**CITY OF SEATTLE
ANALYSIS, RECOMMENDATION AND DECISION OF THE DIRECTOR OF
THE DEPARTMENT OF PLANNING AND DEVELOPMENT**

Application Numbers: 3009571
Council File Numbers: 309754
Applicant Name: Kevin Sutton, architect for Urban Impact
Address of Proposal: 7700 Rainier Avenue South

Land Use Application to allow a four story structure with a total of 63 residential units and 5,730 sq. ft. of commercial space at ground level. Parking for 89 vehicles to be provided at and below grade. Project includes a contract rezone from Single Family 5000 to Neighborhood Commercial 2 with a 40 foot height limit to include all of tax parcel 941240016 and the eastern halves of tax parcels 9412400025, 9412400035, 9412400036, and 9412400045.*

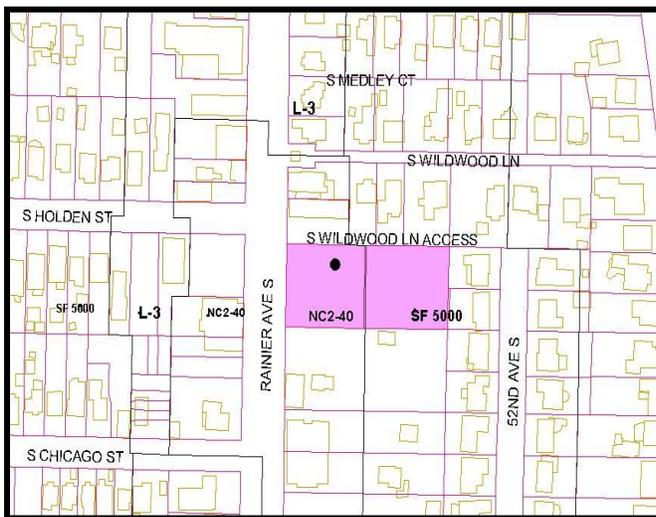
The applicant has proposed the following restriction on the four parcels to the south as part of the NC2-40 rezone request.

- a. Provide increased setbacks in the NC2-40 zone adjacent to residential lots by increasing the setback from 15 to 25 feet for portions of structures over 13 feet.
- b. Preserve a stand of mature trees in parcel tax 9412300025 that provides a natural buffer between the proposed NC2-40 and the adjacent SF 5000 zone.
